Subject: SOFT TOP SPLIT	Bulletin No: 09-003/03
	Last Issued: 2/7/2003

APPLICABLE MODEL(S)/VINS

All 1999-2001 Miata and 2002 Miata with VIN before JM1NB353**0 231580.

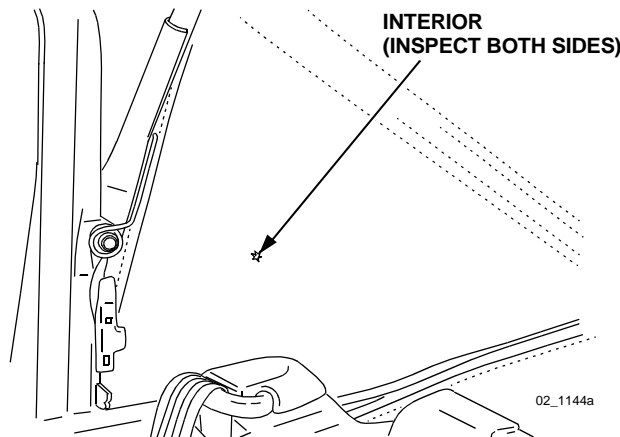
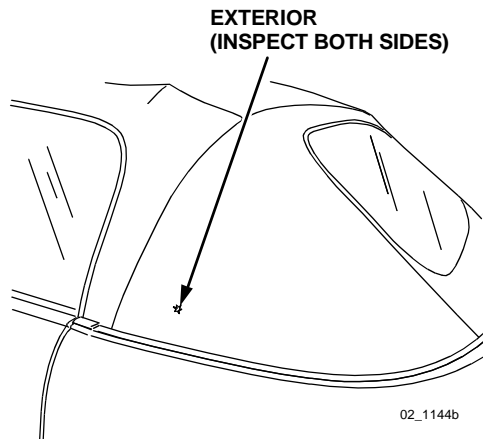
1. Verify condition by inspecting the soft top fabric for splitting or holes in B-pillar area of soft top.
 - If soft top wear marks are visible only at the vehicle interior side and have not worn through to exterior, then soft top replacement is not required. Skip to Step 5 and replace only the RH and LH Set Plates.

- If splitting of holes are visible on the exterior of the soft top, then proceed to the next steps for replacing both the soft top fabric and the set plates.

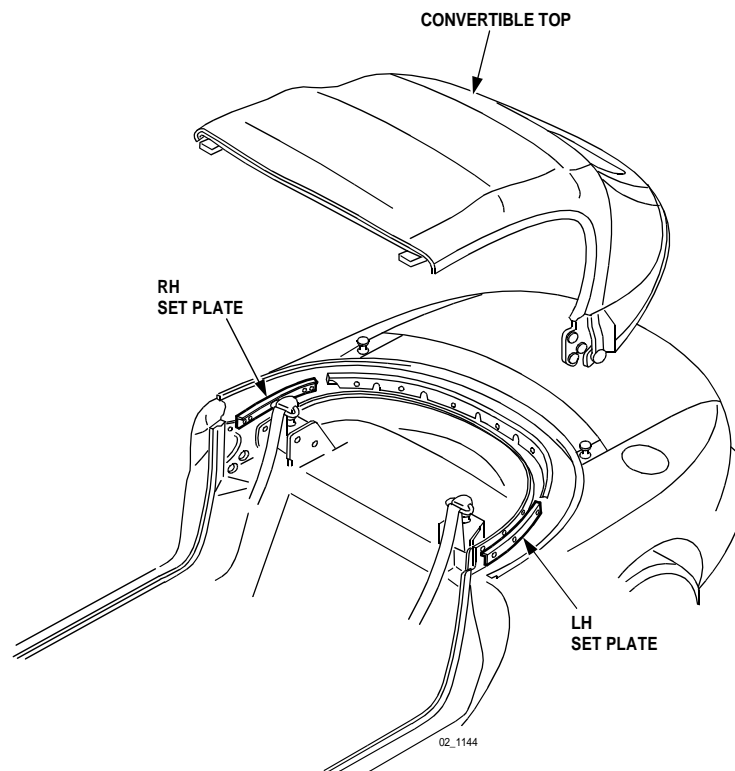
5. Replace the RH and LH Set Plates with a newly revised parts as shown.

NOTE: New revised RH and LH Set Plates must be installed for an effective repair.

Part Number	Description	Qty.	Notes
NC10-R1-582B	Set Plate, RH	1	
NC10-R1-592B	Set Plate, LH	1
